Appendix

Technical Studies and Reports

C) Early Assistance Meeting Notes

PP&D – Early Assistance Land Use Planner Response

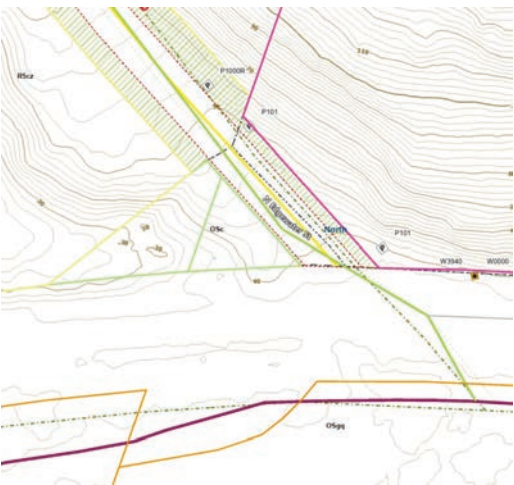
7. Transportation staff note that the submitted materials show a realignment of the N. Edgewater St. rail crossing through the "c" zone approximately 50-ft west of the current location. Transportation staff support realigning the crossing to increase safety as needed. Staff assume the realignment will include removal of the existing roadway. Projects that create new right-of-way or realign a roadway may require approval through environmental review. Staff defer to Land Use Services for approval criteria and process details. If new right-of-way dedication is needed to accommodate the realignment, that is a simple process. Vacation of existing right-of-way is very time and labor intensive. If the applicant team wants to discuss anything about dedication or vacation, please feel free to reach out.
